To: INCITS Technical Committee T10
 From: Kevin Butt
 Date: May 2, 2007 2:23 pm
 Document: T10/06-462r7 — SSC-3: Keyless Copy

4.2.20.4 Keyless copy of encrypted data

FIGURE 1. Flowchart of a keyless copy

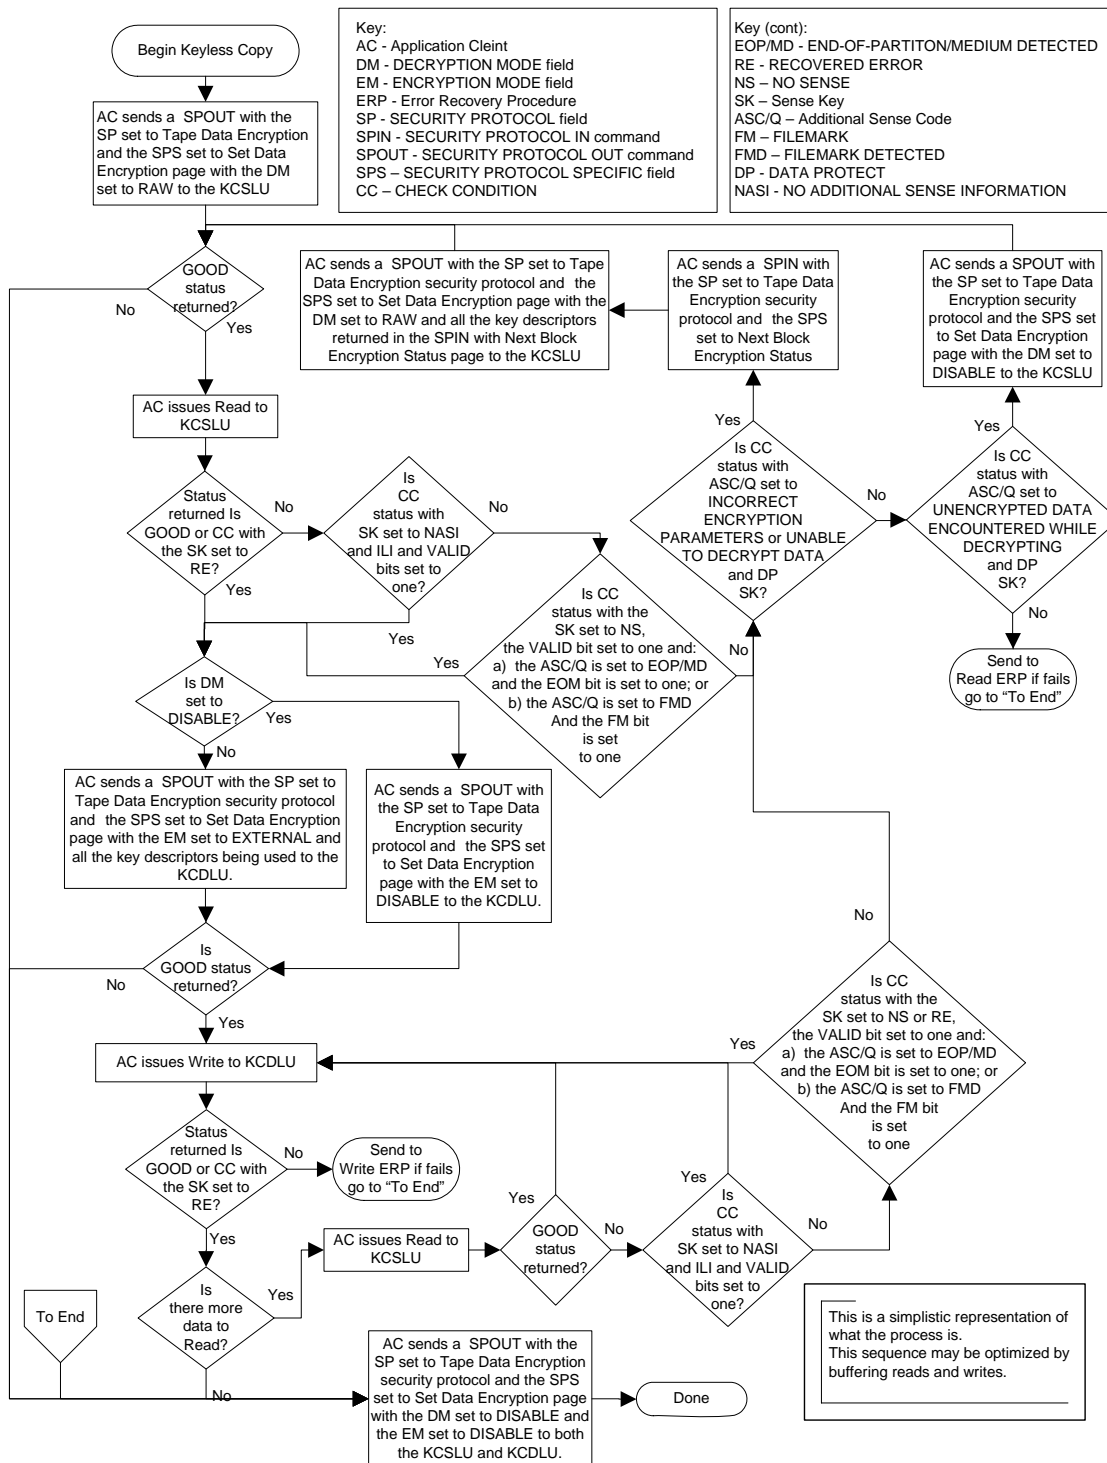
8. 06-462r5 Modified the figure to describe an example of how an application client might implement a keyless copy, listed where to return to the flowchart for ILI and FM Check Conditions.

10. 06-462r7 Correct list for detecting errors in the Set Data encryption pages that contain M-KAD. Modify flowchart to show transitions between unencrypted data and encrypted data during a keyless copy.

To accomplish a keyless copy operation an application client sets the KCSLU decryption mode to RAW and the KCDLU encryption mode to EXTERNAL. The application client then reads one or more logical objects from the KCSLU and writes those logical objects to the KCDLU. During this process if the KCSLU detects a mismatch between the key-associated data in the data encryption parameters and the key-associated data on the medium during a read operation, the KCSLU returns a CHECK CONDITION status to the application client to notify it that some action is required. An example of this is shown in the informative flowchart in Figure 1 on page 5.
